**TOWN OF ERIE
PLANNING COMMISSION AGENDA ITEM
February 5, 2020**

SUBJECT: **Agenda # 20-033:**
A Resolution Of The Planning Commission Of The Town Of Erie Recommending That The Board Of Trustees Approve The Sunset Preliminary Plat With Conditions

Figure 1

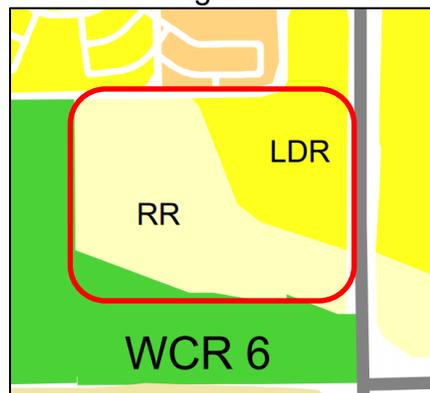
The Comprehensive Plan designates Rural Residential and Low Density Residential land uses within the area of the plat as shown in Figure 1 below. The density anticipated in an RR area is between 0-2 du/ac. In LDR areas the density contemplated is 2-6 du/ac. The anticipated gross density of the project is 2.06 du/acre (238 dwelling units/103.83 acres). The Preliminary Plat application is in general compliance with the Land Use designations on the 2005 Comprehensive Plan, Land Use Plan Map.
